Leaksite No: 14698 Date: 03/07/06

Site name: Former KCs Quick Stop, 230 1st St, Brooten

Review of CAD vapor mitigation system dated May 06

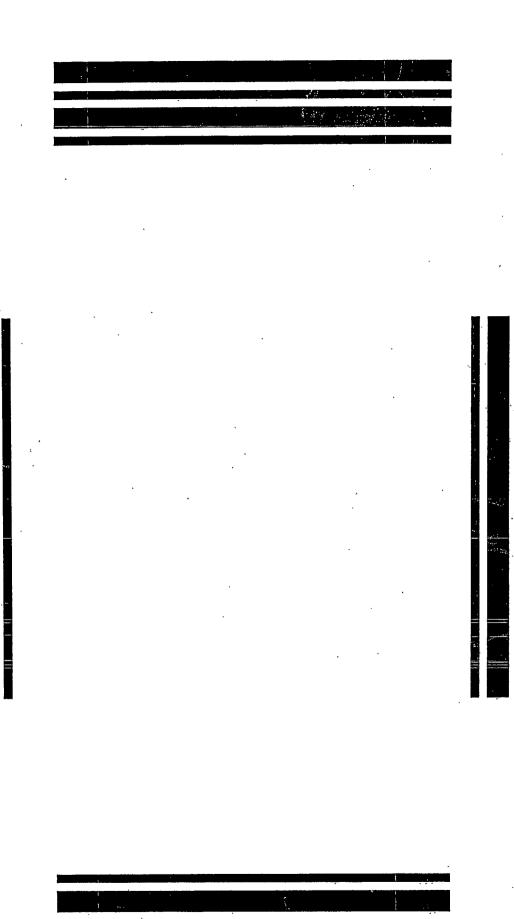
The cistern in the basement was filled in with sands and covered with concrete. This should help in prevent vapor migration into the basement. Indications were that the highest levels of vapors were detected near the cistern

The mitigation system was installed by "Professional House Doctors". It consisted of a 4 inch vent pipe and a blower with the exhaust pipe out the roof of the house. The blower was pulling approx 1 ½ in water at the time of our visit.

Review of the basement showed stored paints and the furnace proximate to the venting area.
